Access Compliance Report

Public Rights-of-Way

(Curb Ramps)

Intersection ID: 51052	Main Street: ARDREY_KELL_RD	Cross Street: N/A	Location: SW
ADA ID: 91FDA363B097	Ramp Type: PerpDiag	Initial Pass/Fail: Fail	Overall Compliance: No
Severity Score: 12.5			
Codes/Mitigation Info/Possible Solution		Field Measurements/Component Compliance

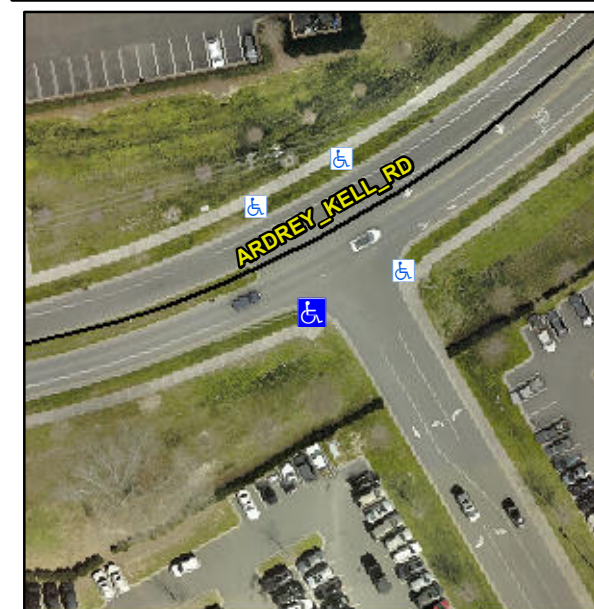
Not Found, R304.5.3

Remove & Replace Curb Ramp With Two New Directional Ramps or Equivalent.
